To: Development Permit Panel **Date:** January 4, 2006
From: Holger Burke **File:** DP 05-302414
Acting Director of Development
Re: **Application by Ah Ten Holdings Ltd. and Hemlock Drive Development Limited
Partnership for a Development Permit at 6288 Katsura Street and
9371 Hemlock Drive**

5. 5-Storey Apartments over Single-Storey Parking

DP 05-302414

PARKING PLAN

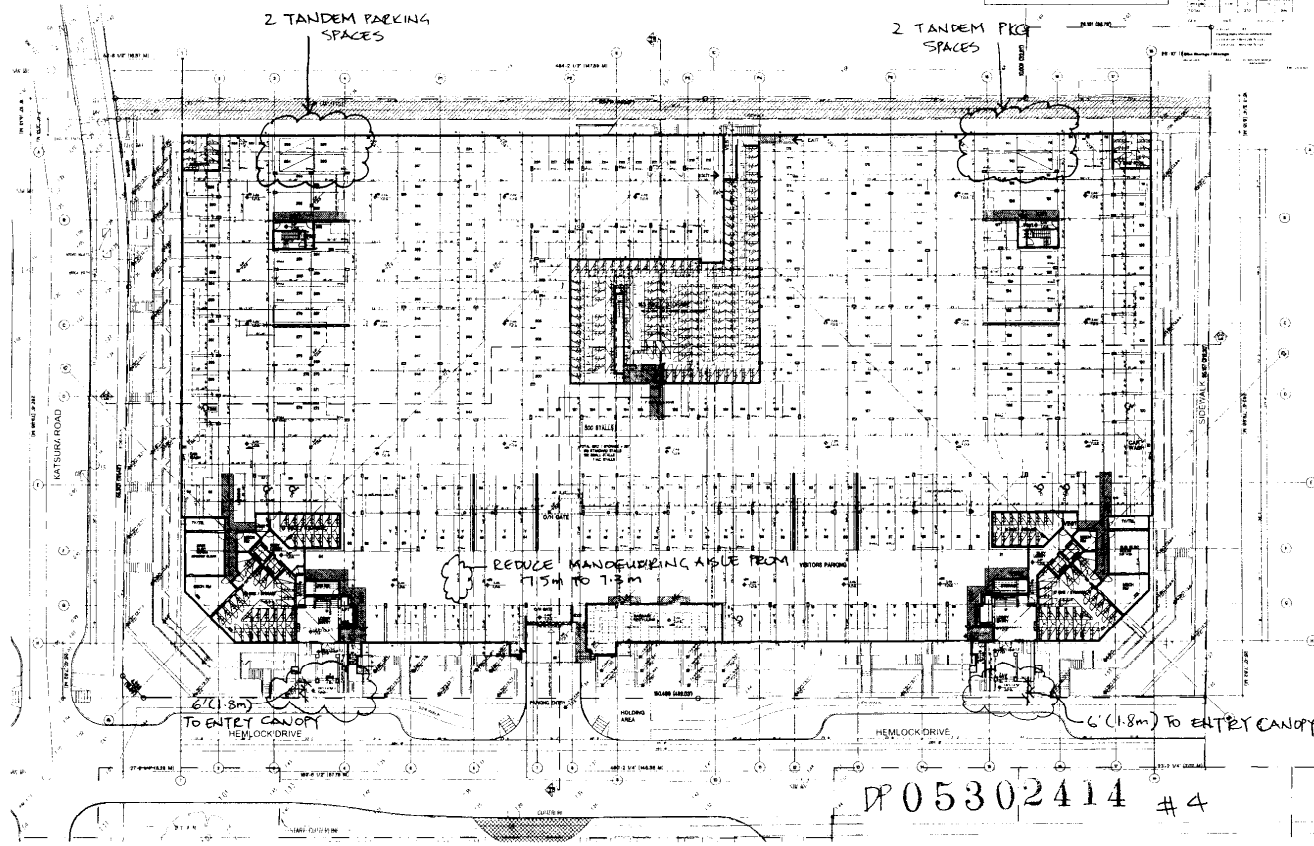
- 2) Permit four (4) tandem parking spaces.

- 3) Vary the manoeuvring aisle from 7.5 m to 7.3 m.

(Staff supports the proposed variance given the minor nature of the variance. Tandem arrangement is preferable to a reduction of parking requirement. The proposed tandem arrangement allows the project to meet the parking requirements in the Comprehensive Development District (CD/68) zone. The Transportation Department has reviewed the proposal and supports the variance as proposed. The proposed development meets the parking requirement).

(Staff supports the proposed variance. The proposed reduction of the aisle width does not pose significant impact to vehicular manoeuvring and helps to achieve a more compact parkade plan in order to meet the parking requirement).

1 SOUTH (FRONT) ELEVATION
 HEIGHT VARIANCE FROM 15 m to 15.4 m FOR THE 5TH FLOOR & 18.15 m FOR ARCHITECTURAL APPEARANCE (ELEVATOR SHAFT)

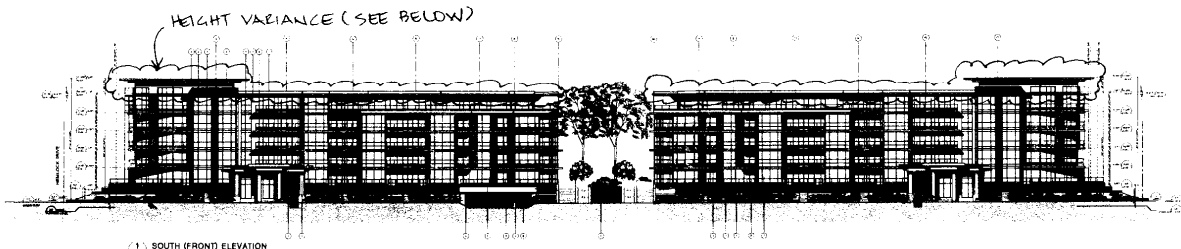
- 1) Increase the maximum permitted building height from 15 m to 15.4 m for the fifth floor of the building and vary the maximum permitted height from 15 m to 18.15 m for a small portion of each of the two (2) buildings for an architectural appurtenance to accommodate the required vertical clearance above the elevator shaft.

(Staff supports the proposed variance. The project has been completely redesigned from a four-storey wood frame construction proposed in the original rezoning application (RZ 96-000162) to two (2) five-storey concrete buildings. The redesign resulted in a significantly improved interface with the park edge, an increase in the common on-site open space and more light and view access to some of the proposed townhouses on the site to the east.

The five-storey building is terraced to minimize shading impact to the park north of the proposed development. The building cannot be lowered further into the ground to avoid the slight height variance without major structural implications due to flood plain requirements. The minimum recommended flood plain elevation for habitable area in this area is 1.5 m (geodetic datum), which is the proposed finished elevation of the first floor of this development. The proposed floor-to-floor height is at the minimum requirement to accommodate the floor to ceiling height and the minimum floor slab. The terracing approach is preferable to a four-storey full height structure at the park's edge for sun access. The massing in the area is intended to step down from highrise buildings on parking podium west of Katsura Road (maximum 45 m), to four-storey buildings on parking podium (between 15 m to 19 m) between Katsura Street and Alder Street and two-storey to three-storey townhouses (maximum 12 m) east of Alder Street.

The slight increase of shadowing generated by the height variance for the architectural appurtenance (clearstory windows to conceal elevator shaft) does not have a negative impact on surrounding development as the elevator shaft is limited in size and set back from the building facades. The proposed development is surrounded by roads to the east and south,
